FORT TOTTEN TRANSFER
STATION WASTE FACILITY
4900 BATES ROAD NORTHEAST
WASHINGTON DC 20011

REVISIONS	
1.	REV1 PRELIM COMMENTS 1: 05.08.2018
2.	REV2 DPW COMMENTS 1: 05.17.2018
3.	REV3 DPW RFI & COMMENTS: 10.09.2018
4.	REV4 BIDDING Q&A : 12.10.2018

FORT TOTTEN:
TIPPING FLOOR BOOTHS &
SECTION DETAILS

A.6

6 SECTION DETAIL - CONCRETE CHANNEL
SCALE: NOT TO SCALE

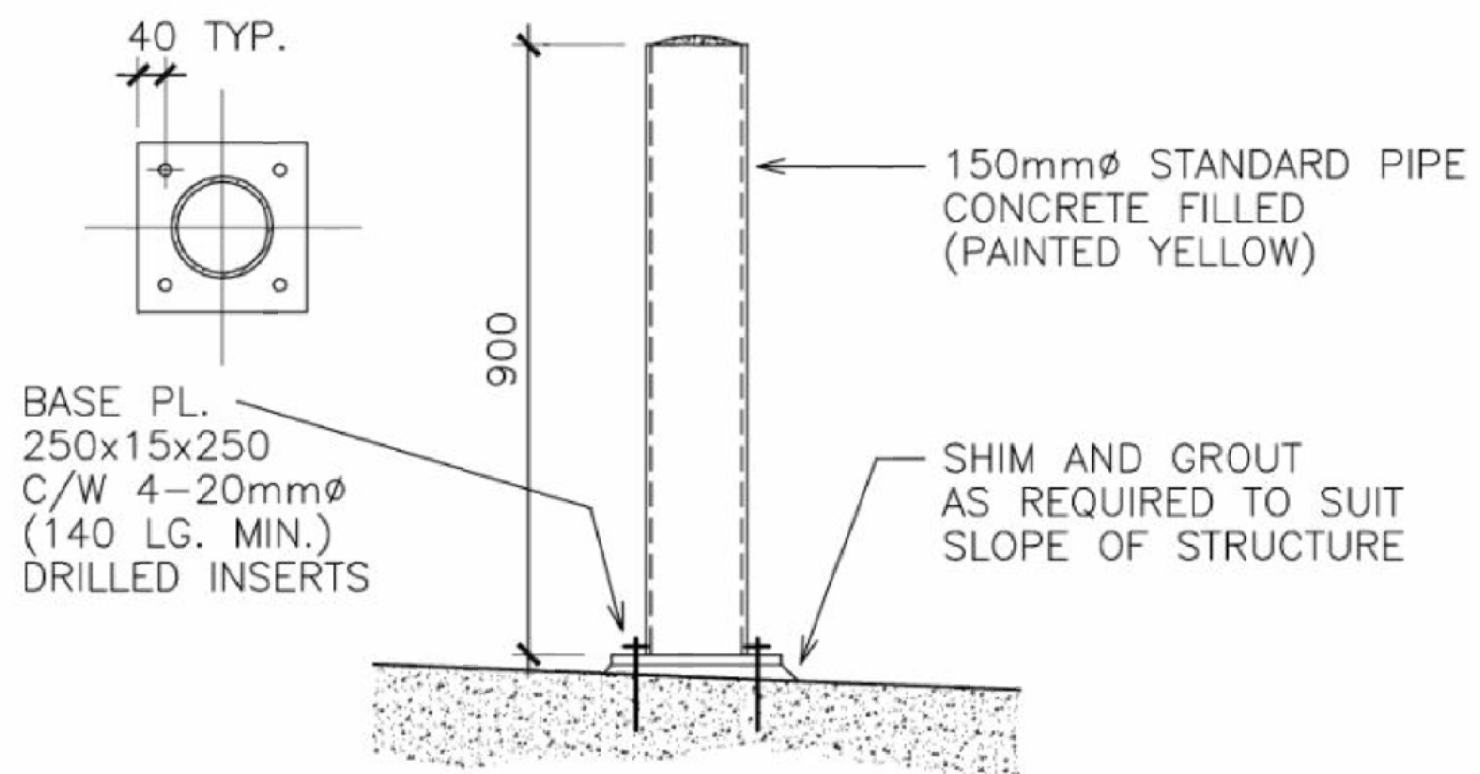
PER THE CIVIL DRAWING CIV 317 AND REVISED ARCH DRAWING ATTACHED A.6 - LIQUID APPLIED WATERPROOFING WILL OCCUR ABOVE THE CHANNEL WHILE WATERPROOFING MEMBRANE WILL EXTEND TO A DEPTH OF 2' BELOW THE CHANNEL.
